**Subject:** Updated System Report for Allyn Property, BRRTS # 02-31-564071

# Vapor Mitigation System designed and installed by A-1 Vacuum & Radon at 111 Steele St. Algoma, WI, on 6/22/17

**Subject:** RE: System Report for Allyn Property, BRRTS # 02-31-564071

<u>Diagram 1</u> Vapor Mitigation location and Vapor Pressure Readings

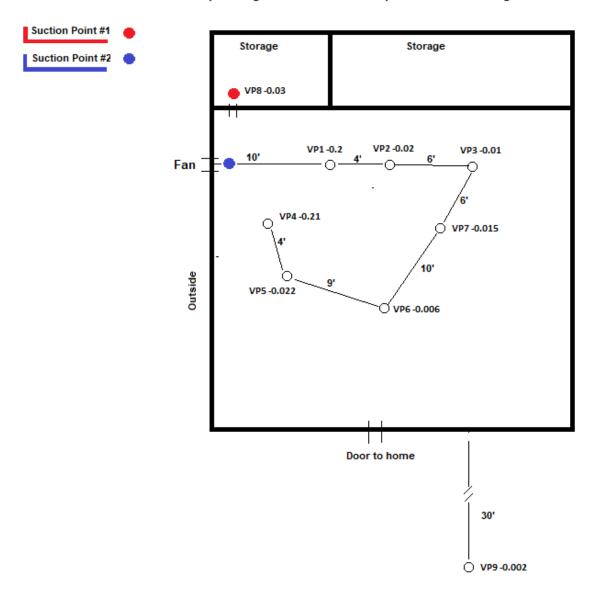
Please review & advise if this updated report meets requirements or needs additional updates. Once complete, my understanding is that you will submit our report to Tauren Beggs at the DNR for final approval.

<u>Diagram 1</u> Vapor Mitigation location and Vapor Pressure Readings

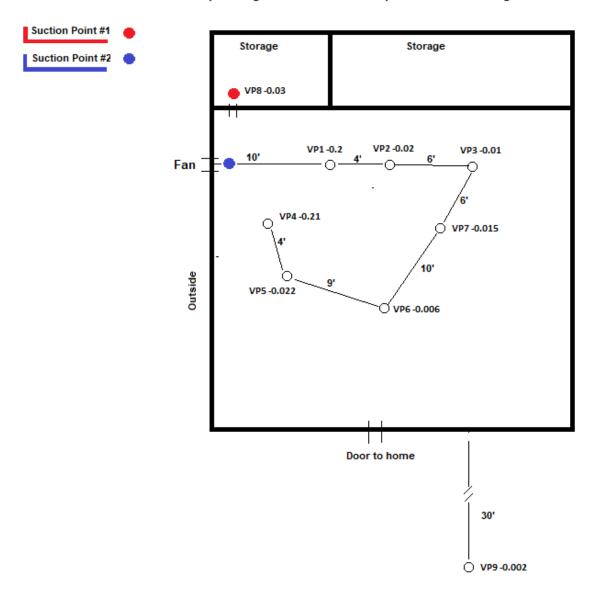
Does the contractor have the other documentation (photos of the system, system design figure(s), system information/manual) that he could provide to you or Don that could be provided as follow up documentation? The other thing I am wondering about is the communication testing results. On the figure provided, the individual communication testing locations (VP1 – VP9) all show positive readings. Sub-slab depressurization systems are designed to achieve lower sub-slab air pressure relative to indoor air pressure, so vapors don't migrate into the building. Therefore, communication testing should show negative readings, not positive. This should be clarified with the contractor to determine if these readings are positive or negative.
